BOARD ACTION REPORT – APPEALABLE ITEM

Project Name: 215 NE 7th Avenue

SITE PLAN REVIEW AND APPEARANCE BOARD STAFF REPORT

File No.: 2019-001-SPM-SPR-CL5

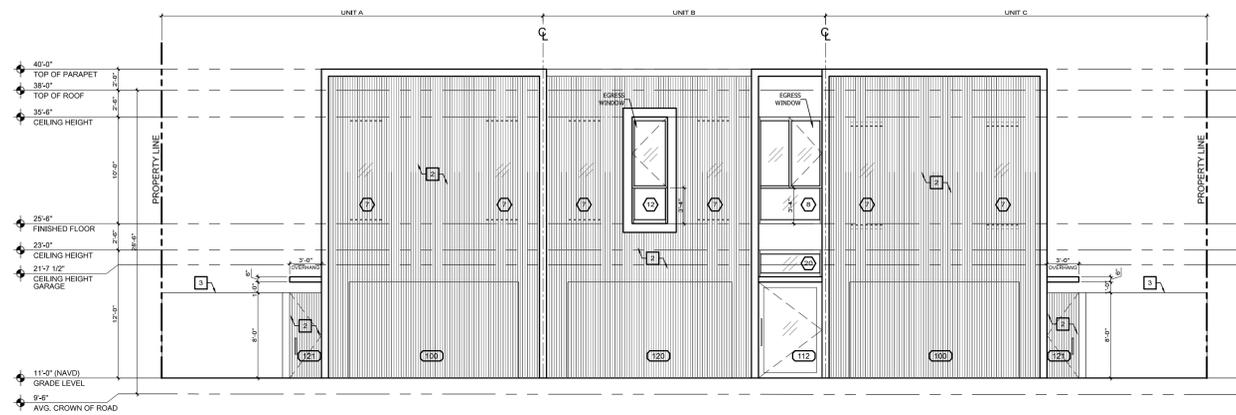
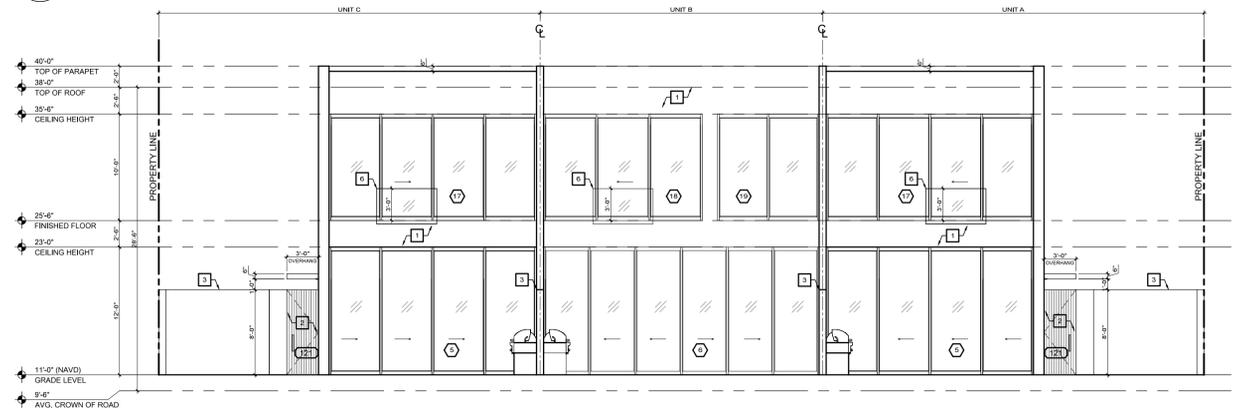
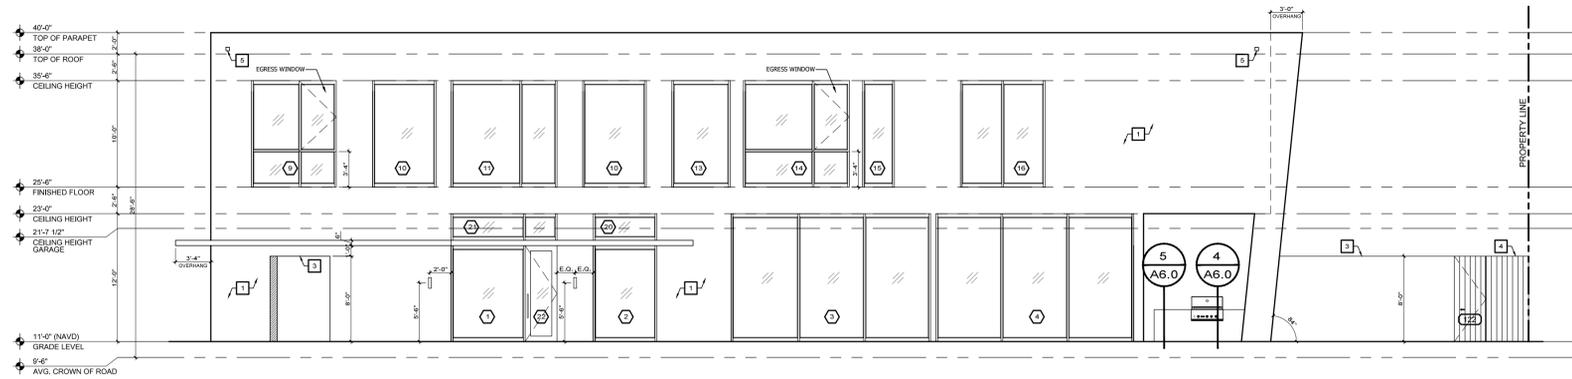
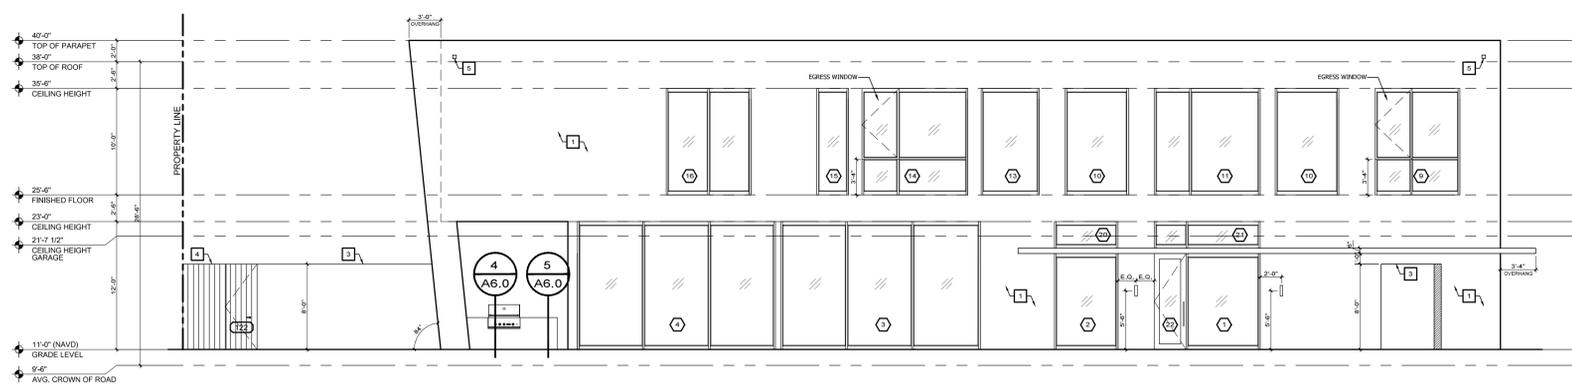
Internal Adjustment approved (7-0) Site Plan approved (6-1 John Brewer dissenting) Landscape Plan approved (5-2 John Brewer and Price Patton dissenting) Architectural elevations denied (2-5).

Board comments were not supportive of the requests for the architectural plan. Several of the board members expressed concern that another Masonry Modern type development was being developed on this street and that maybe a text amendment to the LDR’s was in order.

Several members of the community spoke against the project due to the proposed landscaping and architectural elevations.
